RPRC DETERMINATION LETTER

Project Description: New two story modular home, (5) bedrooms, (6) bathrooms, (3) car garage, and pool

34 CREEMER RD

Zoning District: R-2A Tax ID: 108.04-2-14 Application No.: 2023-0515

TITLE: FRONT ELEVATION

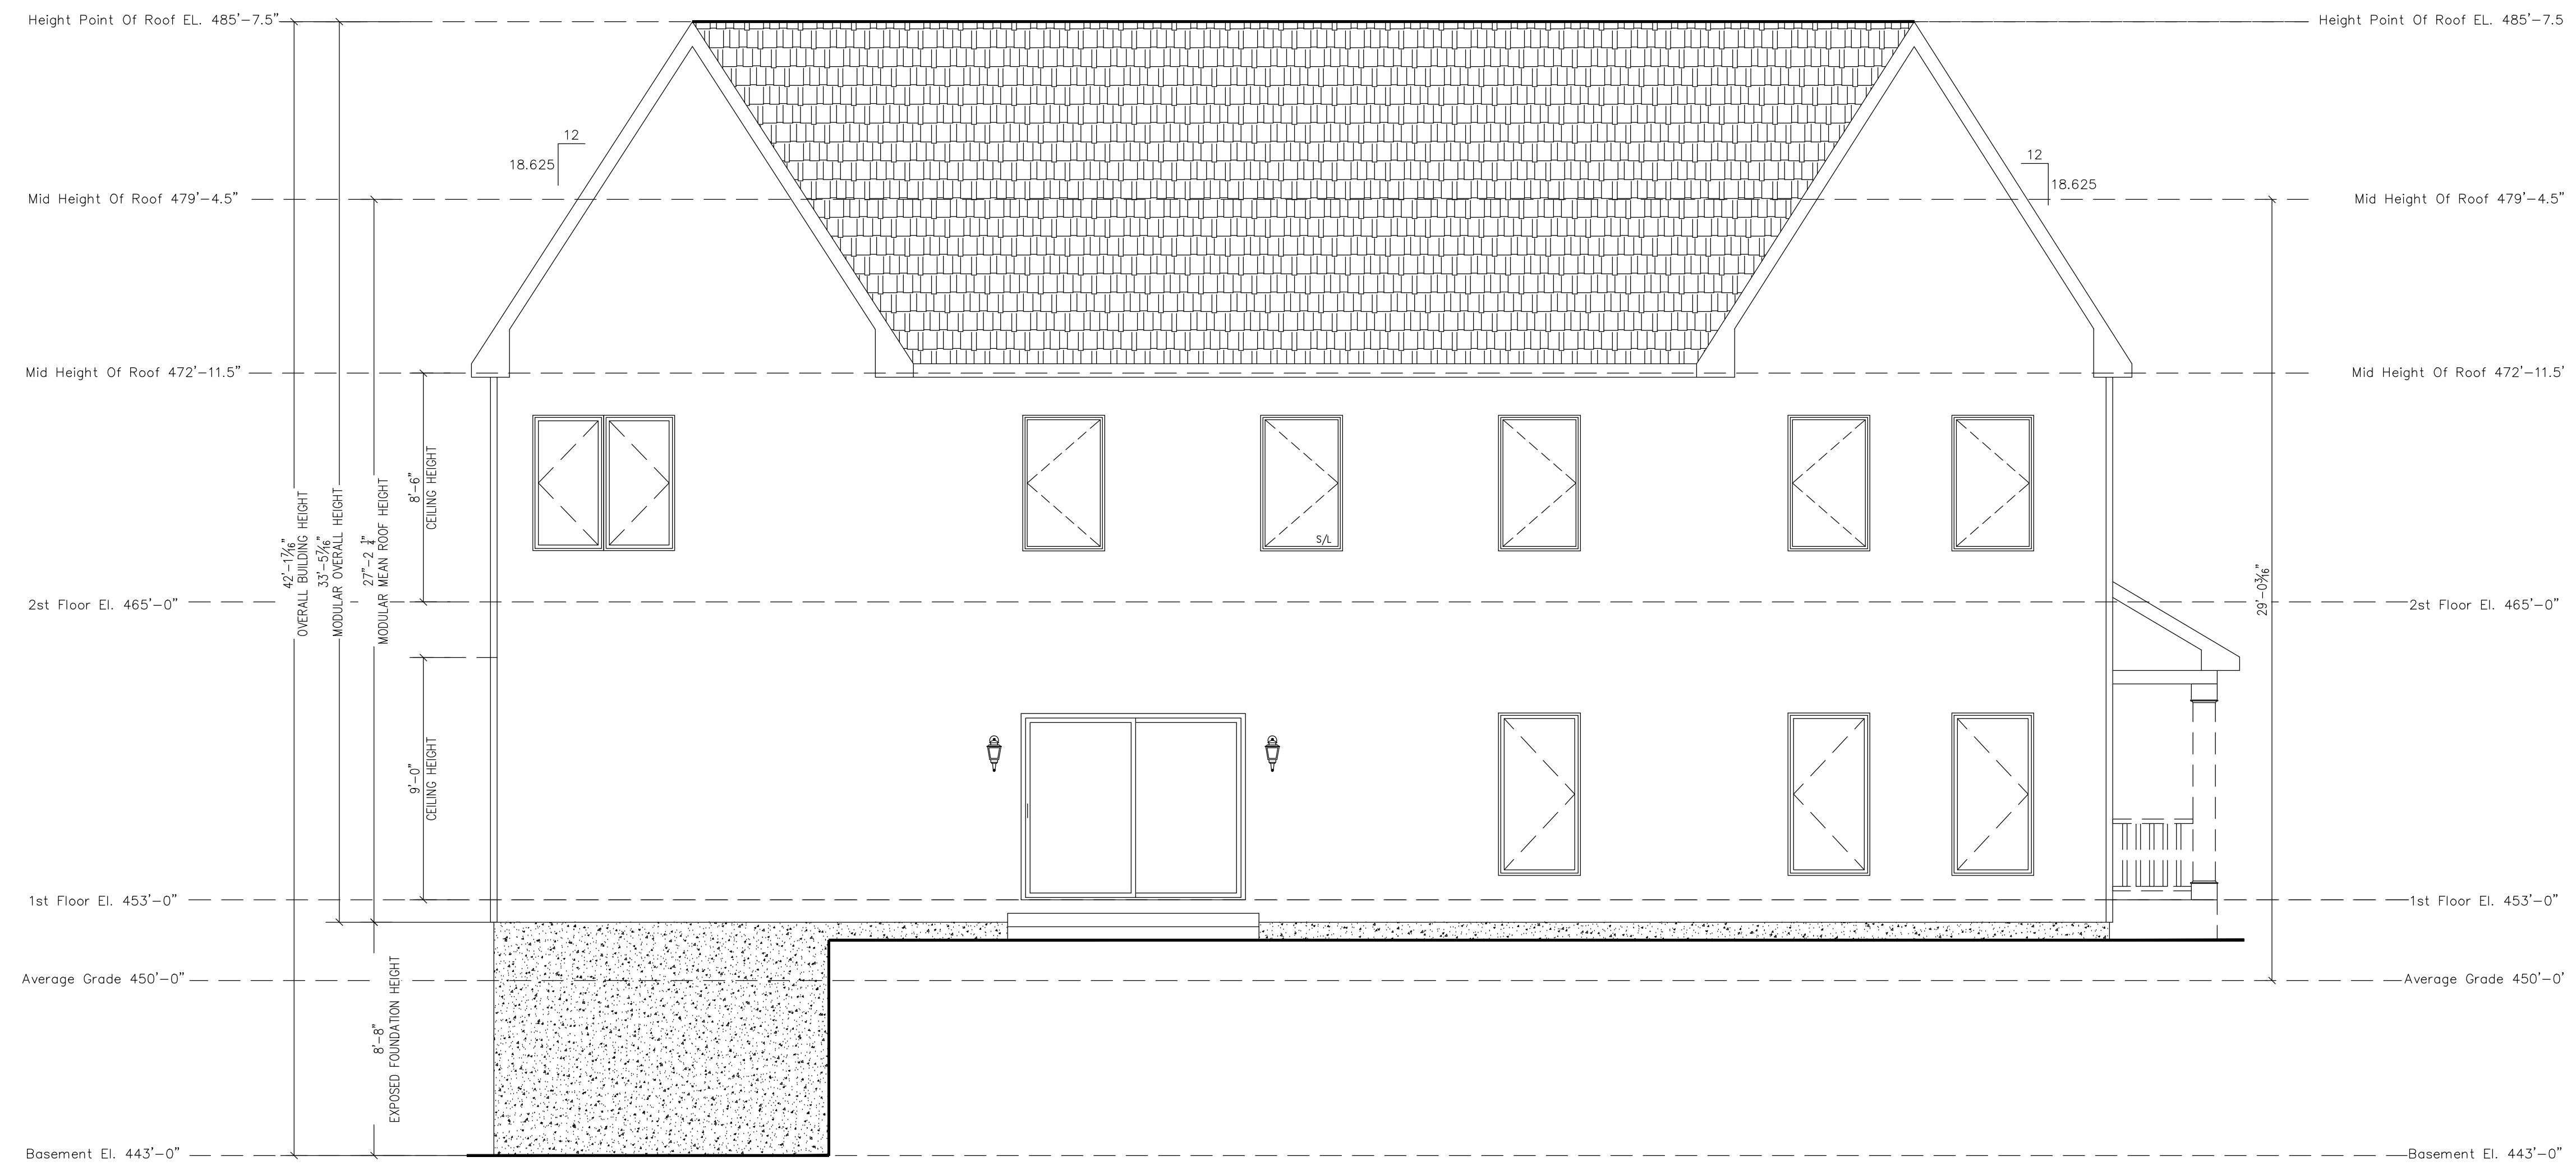
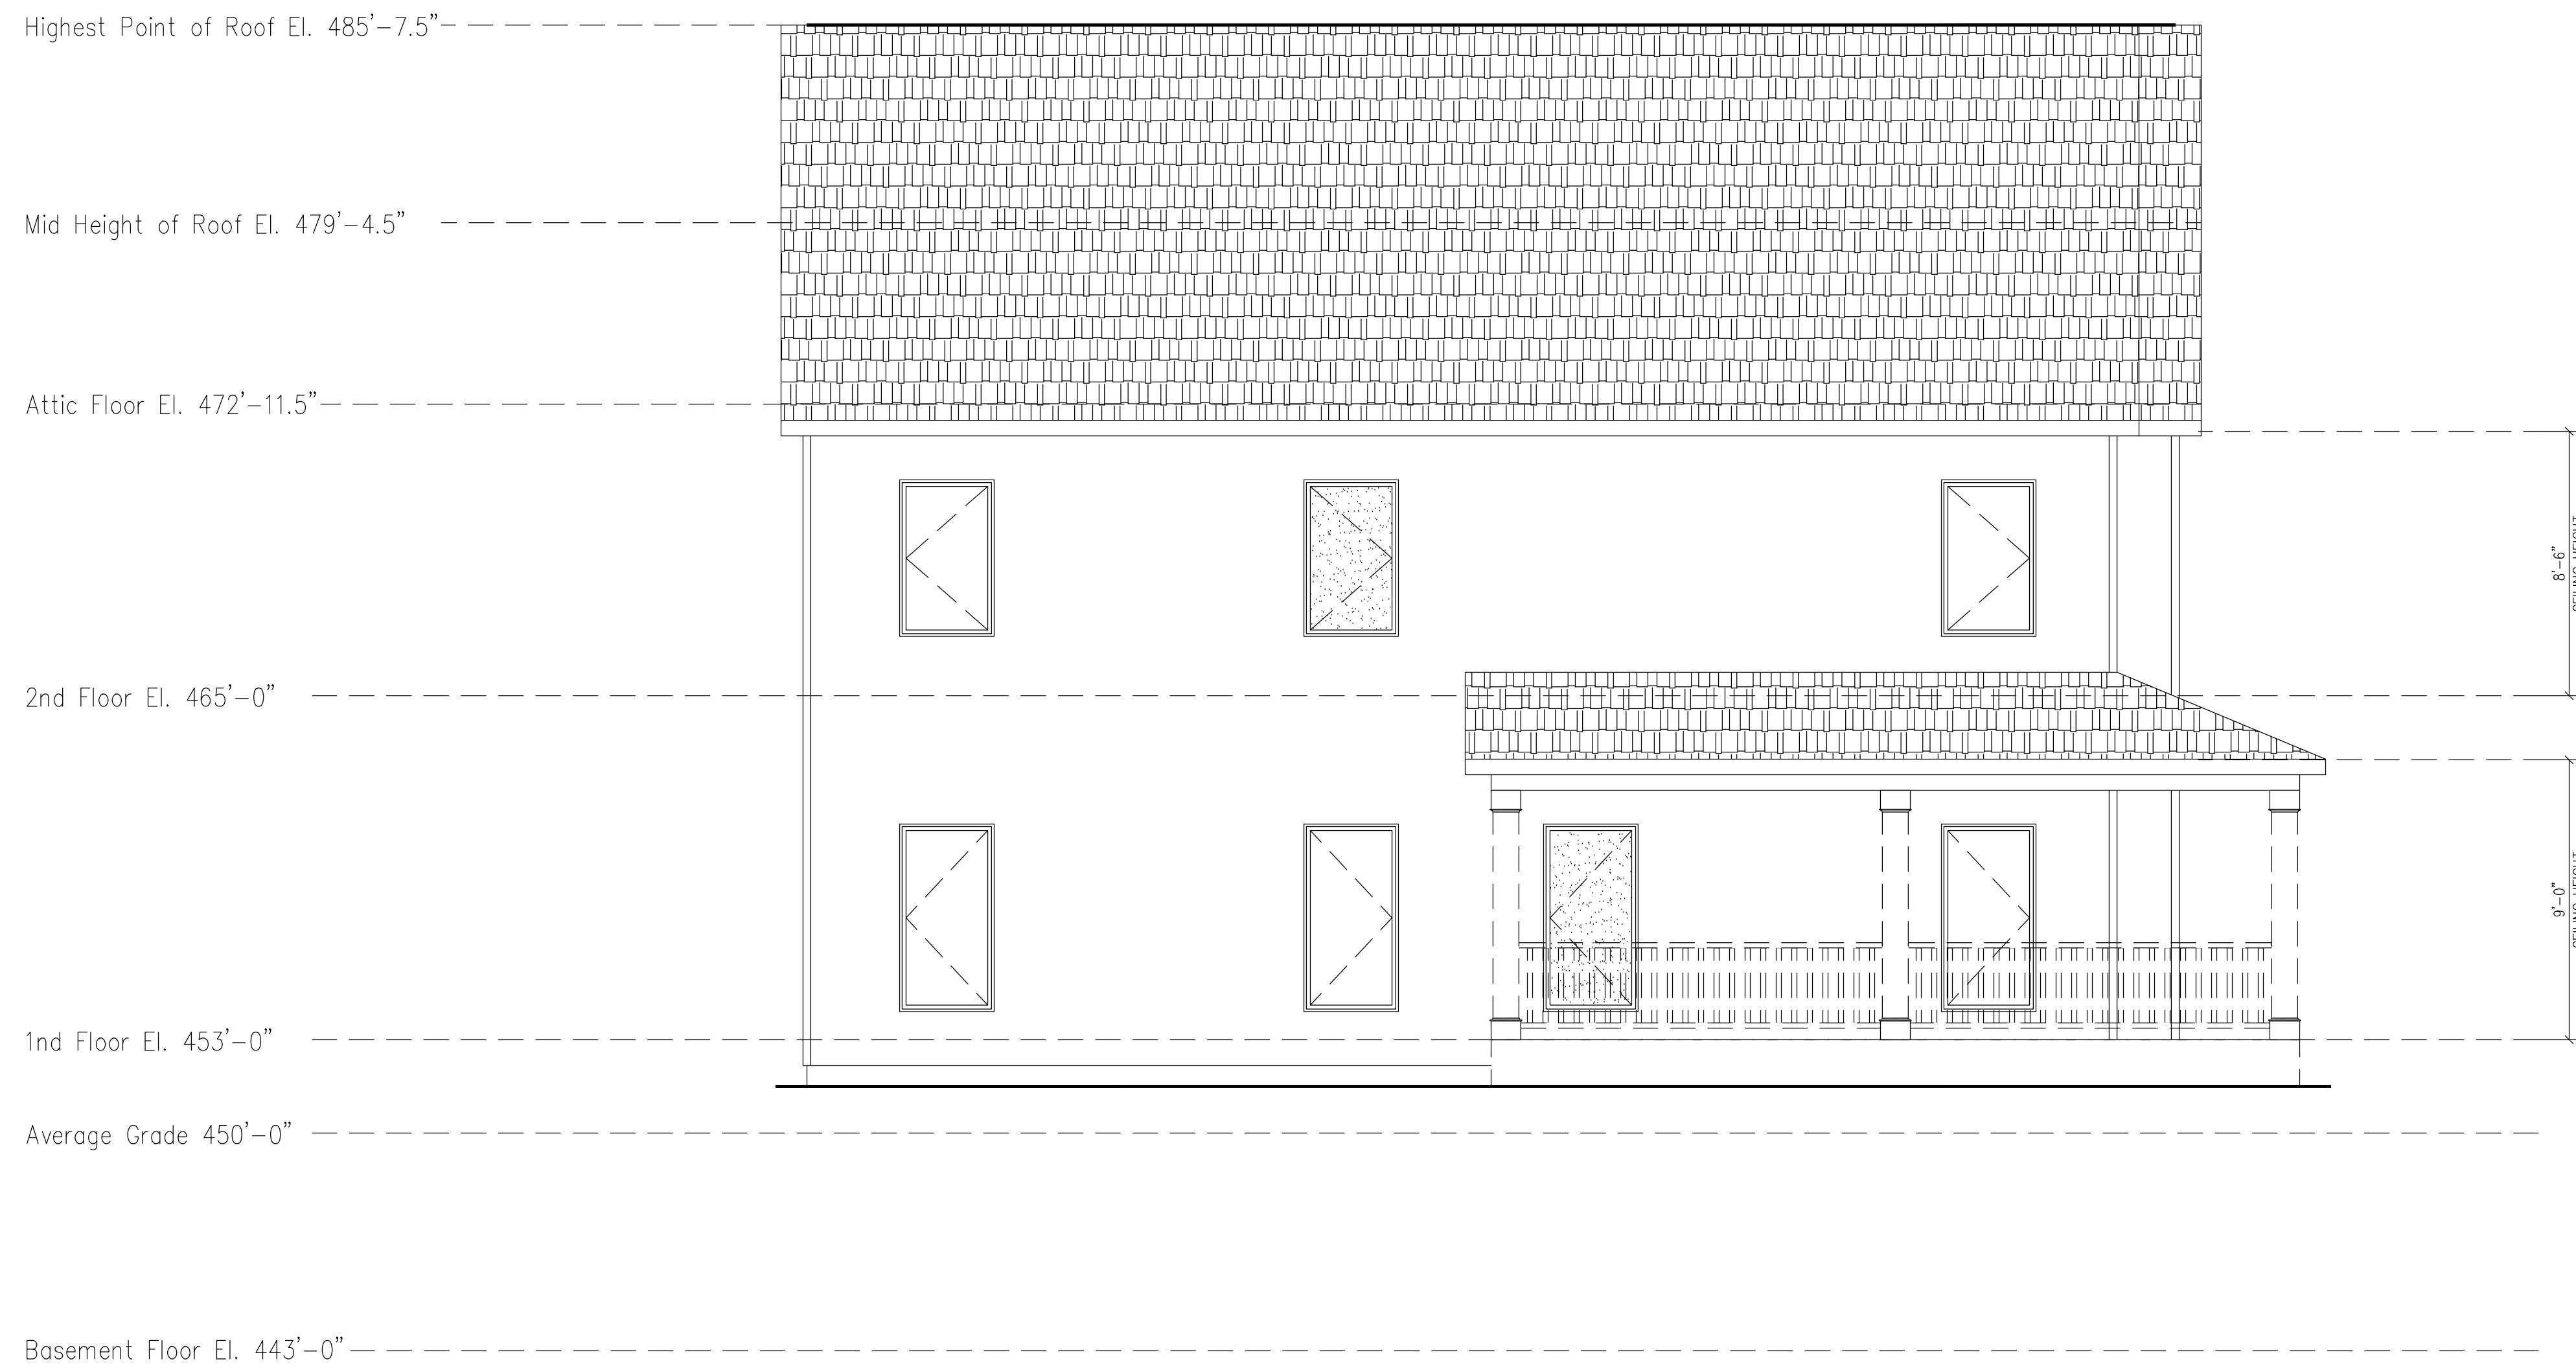
- In addition, the Applicant didn't provide an updated mitigation plan for review. Some of the submitted elevations are not two dimensional. The submitted elevations should be in two dimensions with an elevation submitted for each side. The Applicant can submit proposed renderings for additional information.

- The elevations should be revised to depict Building Height (average grade to roof midpoint - max 30 feet) and Max. Ext. Wall Height (lowest grade to roof midpoint - max 38 feet).
